Model: Apollon-C1		Date: 21-Aug-06	No.: MB222001
Modified Article: Parts Catalog Correction		Prepared by: K. Hamada	
From: 1st Tech. Support Sec. Service Support Dept.			
Reason for Modification:	☒ Parts catalog correction ☐ Vendor change ☐ Other ☐ To facilitate assembly ☐ To improve reliability ☐ To meet standards ☐ Part standardization ☐ Product Safety ()

Model: Apollon-C1		Date: 15-Sep-06	No.: MB222002
Modified Article: Oil Supply Roller		Prepared by: K. Hamada	
From: 1st Tech. Support Sec. Service Support Dept.			
Reason for Modification:	☐ Parts catalog correction ☐ Vendor change ☐ Other ☐ To facilitate assembly ☒ To improve reliability ☐ To meet standards ☐ Part standardization ☐ Product Safety ()

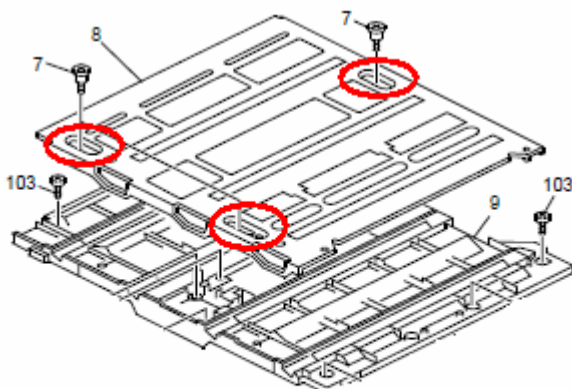
Change: The width of the threaded screw hole was changed from 6mm to 7mm.

Reason: To reduce the stress between the screw and the shutter unit.

Attachment position for the 11028511 CONNECTOR:1-172165-2:

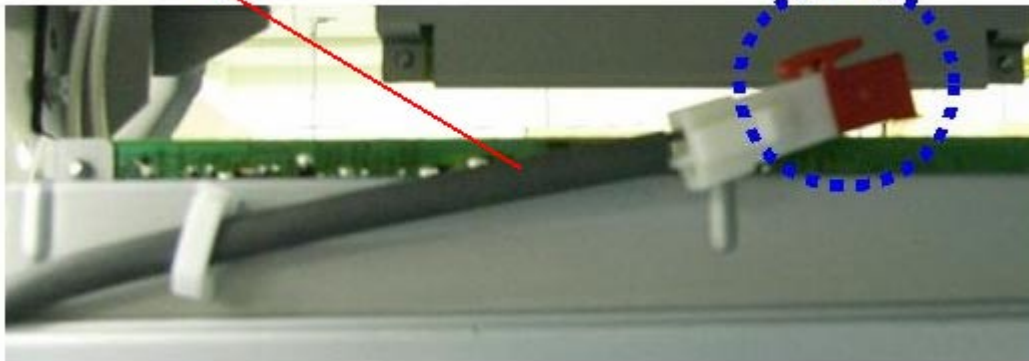
Old part number	New part number	Description	Q'ty	Int	Page	Index	Note
	11028511	CONNECTOR:1-172165-2					*
B2235330	D0295320	HARNESS:AC:SW	1	O/O	101	24	
B2235332	D0295331	HARNESS:PSU:SWITCH:NA	1	O/O	93	7	
B2235333	D0295339	HARNESS:AC:INLET	1	O/O	93	10	
B2235336	D0295319	HARNESS:POWER SUPPLY UNIT:JIGU	1	O/O	93	5	
B2235350	D0295312	HARNESS:IOB:CONNECTING:D RUM:SENSOR	1	O/O	99	8

***Note:** The connector is for areas with an AC supply voltage of 200V or more.

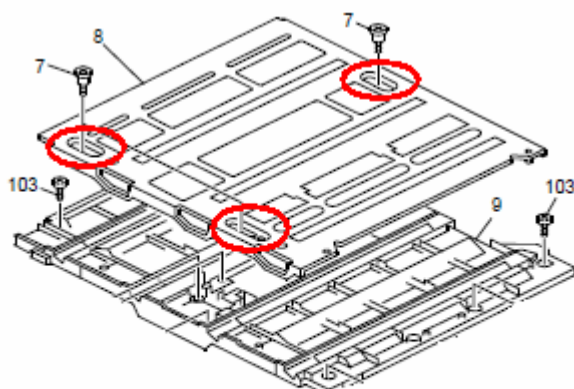
Change: The width of the threaded screw hole was changed from 6mm to 7mm.

Reason: To reduce the stress between the screw and the shutter unit.

1.EXTERIOR (B800)

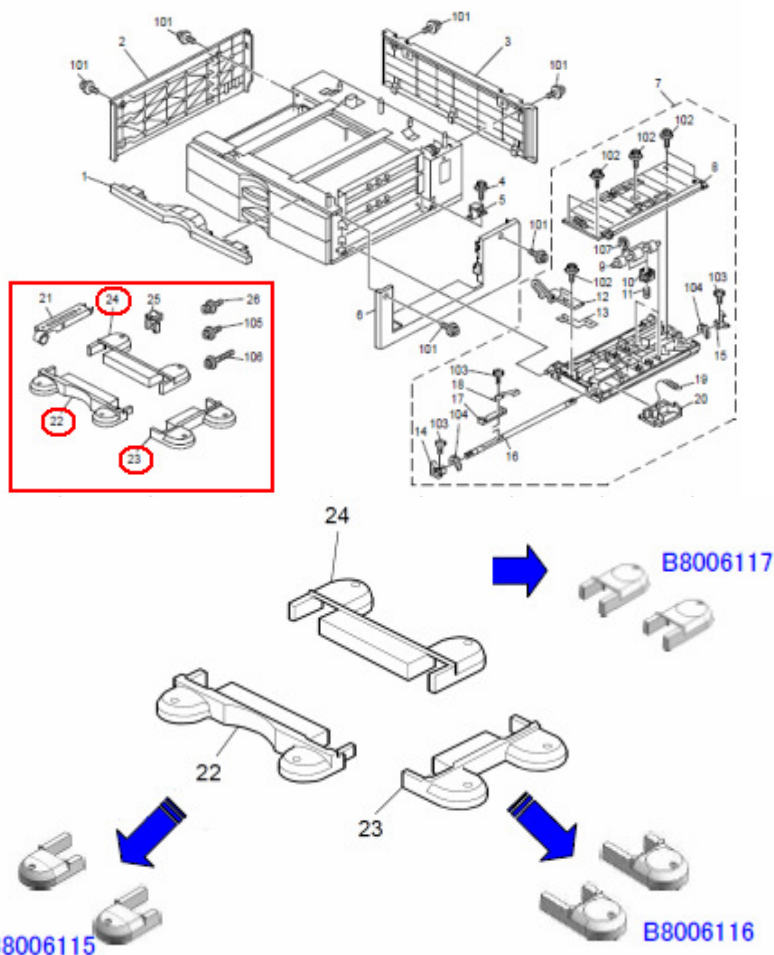
Old part number	New part number	Description	Q'ty	Int	Page	Index	Note
B8016115	B8006115	Arm Cover - Front	1->2	X/O As a set	3	22	
B8016116	B8006116	Arm Cover - Right	1->2		3	23	
B8016117	B8006117	Arm Cover - Rear	1->2		3	24

Change/Reason: The shapes of the arm covers were changed to improve stability.

Illustration 1: Two clips (P/N A2222724) added in the fusing unit:

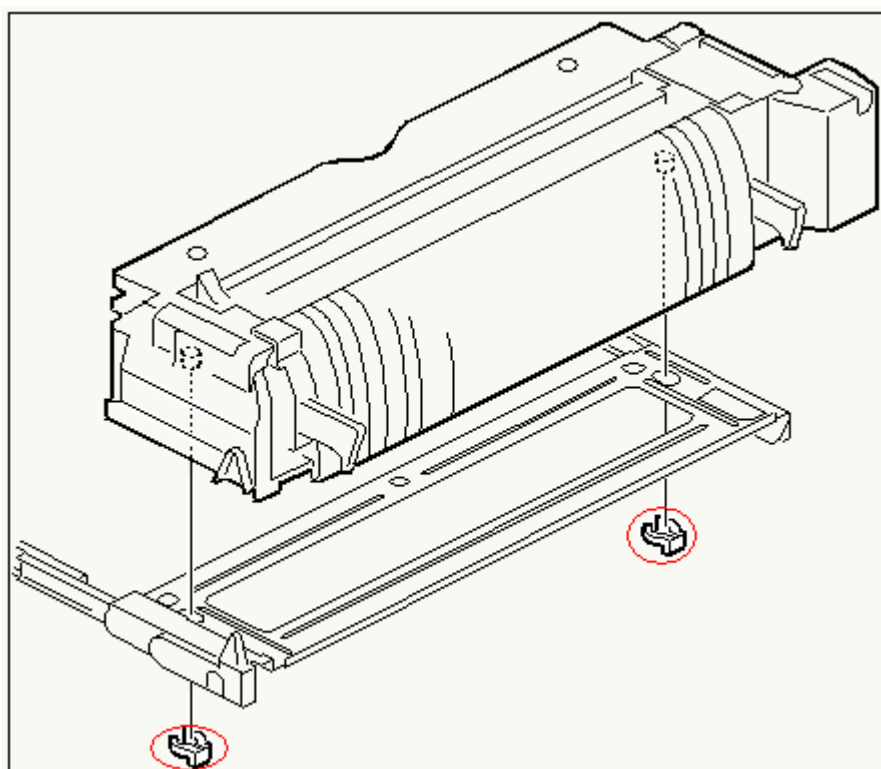
-Two P/N **A2222724** clips are now used in the fusing unit. (see **Illustration 1**)
